IS F

OUTLINE OF NEW FEATURES

The following changes have been made for the new IS F.

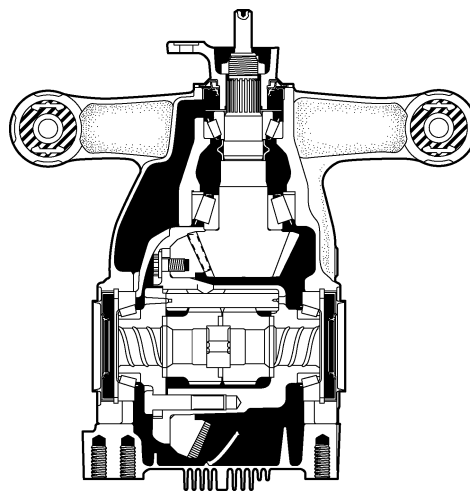
- The design of the audio head unit has been changed, and the following functions have been added for the audio head unit. For details about the line-up, [see page 18](#).

- A USB port provided to enable playing music data that is stored on a USB memory stick or iPod*.
 - The Bluetooth audio system enables users to enjoy music played on a portable audio player from the vehicle speakers via wireless communication.

10M0NF05C

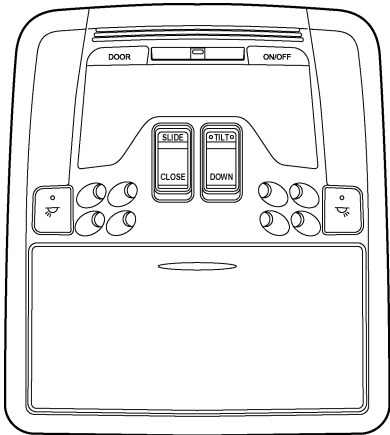
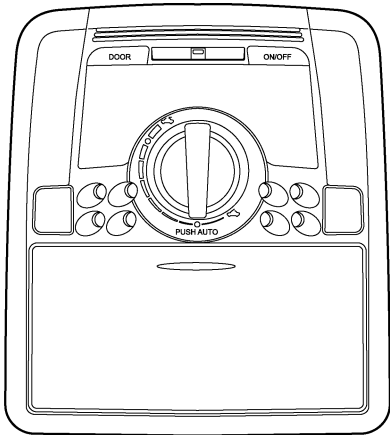
The sliding roof control switch has been changed from the dial/push type to a momentary type.
